THRUSH AIRCRAFT, INC.

SERVICE BULLETIN

No. SB-AG-54

S2R-T660 ELEVATOR

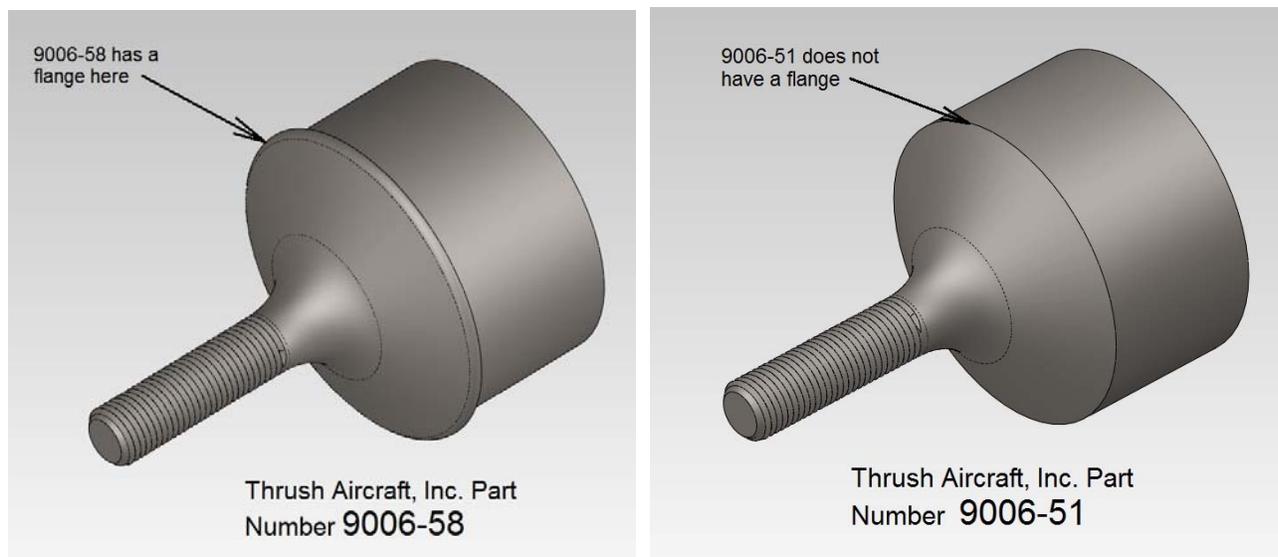
If not replaced, the threaded portion of P/N 9006-51 end fitting must be magnetic particle inspected

within 25 flight hours, and every 100 flight hours thereafter, until replaced with the P/N 9006-58 end fitting. The end fitting may be inspected in place by disconnecting the rod end bearing from the belcrank and backing it and the check nut out so as to expose 8 threads past where it was installed. Screwing the rod end bearing back in after inspection exactly the same number of turns it was backed out will make re-rigging unnecessary.

Magnetic particle inspection must be accomplished according to ASTM E 1444-01, using wet particles meeting the requirements of SAE AMS3046F. If cracks are found the part must be replaced with a serviceable part prior to further flight.

To replace the existing P/N 9006-51 end fitting with the new P/N 9006-58 end fitting, accomplish the following steps: See illustrations below for visible difference between 9006-58 and 9006-51.
